53 YORK STREET

# APPLICATION FOR PERMIT

# BUILDING PERMIT REPORT

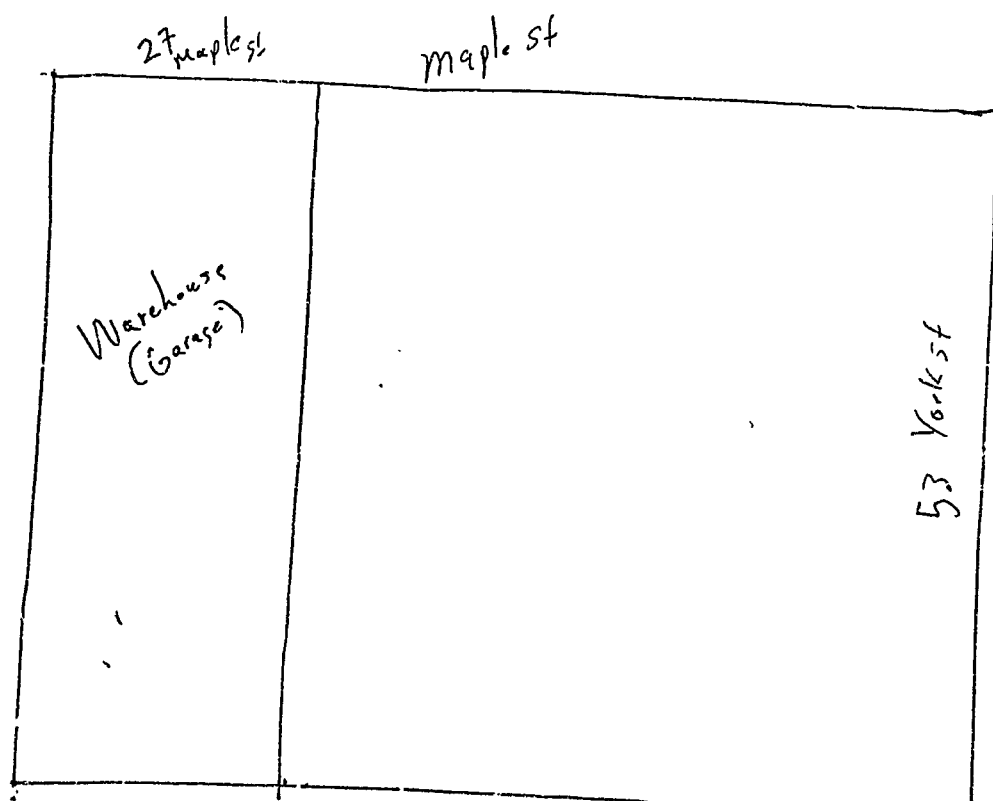
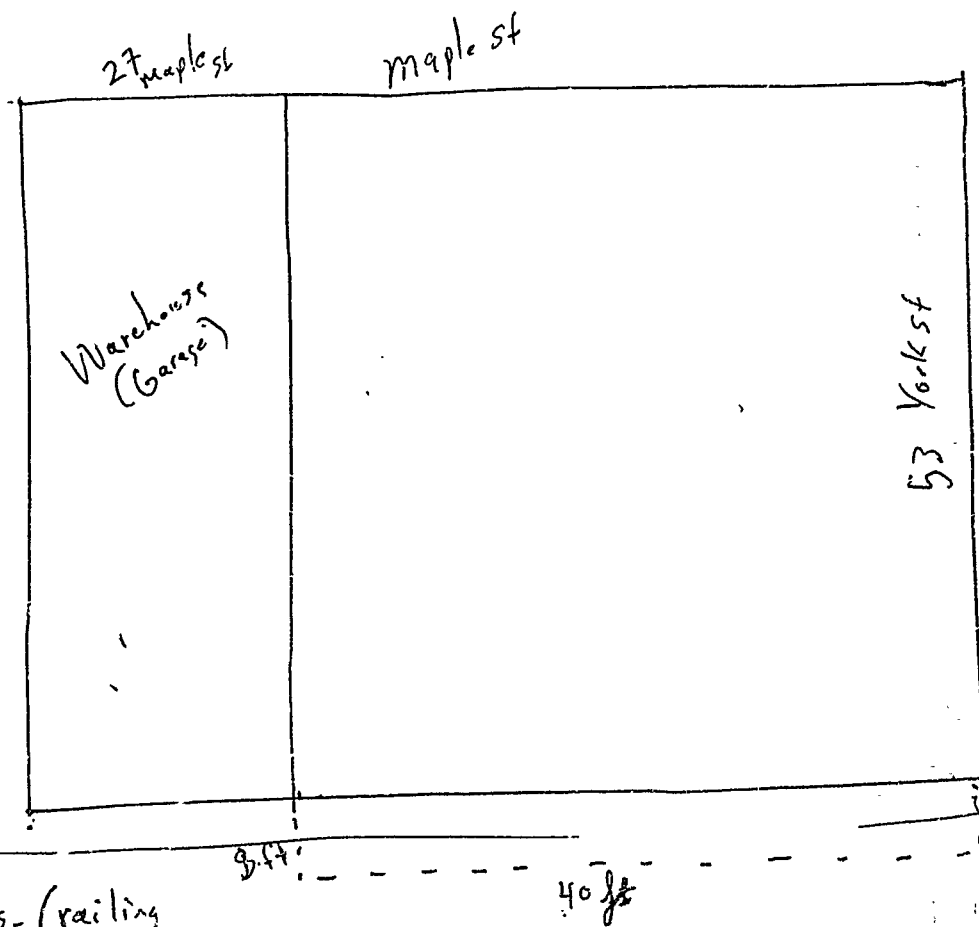
This is an 8ft x 40ft  
 Patio with wooden railing. (railing  
 comes down 10/31/91) on 6/3/91  
 Mr. Mitchell says the railing located  
 toward York St. ~~8~~ - should be ~~6~~ 42" in  
 height.

wooden railing. (railing  
10/31/91) on 6/3/91  
said the railing located  
at. ☆ - should be ~~60~~ in  
42"
